Access Compliance Report

(Curb Ramps)

Intersection ID: 23690	Main Street: CRESSIDA_DR	Cross Street: E WESTINGHOUSE BV	Location: NE
ADA ID: 33626D1CB888	Ramp Type: PerpDiag	Initial Pass/Fail: Fail	Overall Compliance: No
Severity Score: 13.75			
Codes/Mitigation Info/Possible Solution		Field Measurements/Component Compliance

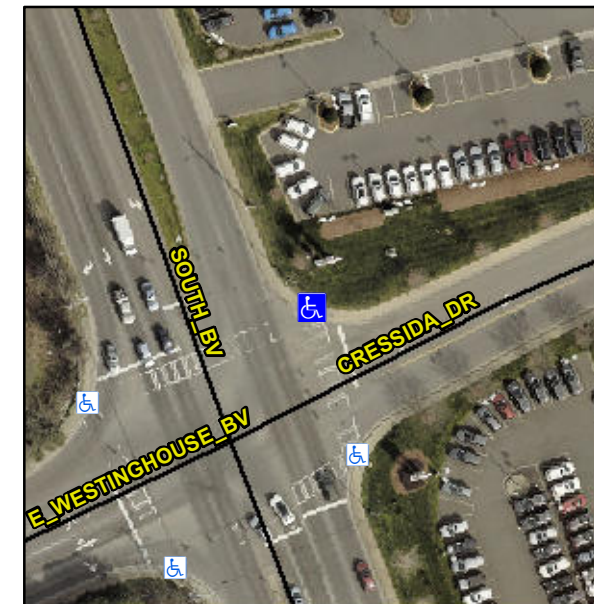
Not Found, R304.2.2, R304.5.3

Compliance	Description	Data	Compliance	Description	Data
N/A	Ramp Length (in)	58.0	No	Ramp Slope (%)	11.8
Yes	Ramp Width (in)	48.0	No	Ramp XSlope (%)	2.4
N/A	Flare Type LT	N/A	N/A	Flare Type RT	N/A
N/A	Flare Slope LT (%)	N/A	N/A	Flare Slope RT (%)	N/A
N/A	Flare Traversable LT?	N/A	N/A	Flare Traversable RT?	N/A
N/A	Landing Length (in)	N/A	N/A	DWS Provided?	N/A
N/A	Landing Width (in)	N/A	N/A	DWS Contrast?	N/A
N/A	Landing Slope (%)	N/A	N/A	DWS Length (in)	N/A
N/A	Landing X Slope (%)	N/A	N/A	DWS Full Width?	N/A
N/A	Landing Curb? (Y/N)	N/A	N/A	DWS Offset (in)	N/A
N/A	Shared Landing?	N/A			
N/A	Gutter Ponding?	N/A	N/A	Gutter Slope (%)	N/A
N/A	Gutter Lip Ht (in)	N/A	N/A	Gutter X Slope (%)	N/A
N/A	Painted X Walk1?	Yes	N/A	Painted X Walk2?	Yes
	X Walk 1 Direction	To W		X Walk 2 Direction	To S
N/A	X Walk 1 Width (in)	114.0	N/A	X Walk 2 Width (in)	114.0
	X Walk 1 Slope (%)	0.1		X Walk 2 Slope (%)	0.5
	X Walk 1 X Slope (%)	0.9		X Walk 2 X Slope (%)	0.3

Remove & Replace Curb Ramp With Two New Directional Ramps or Equivalent.
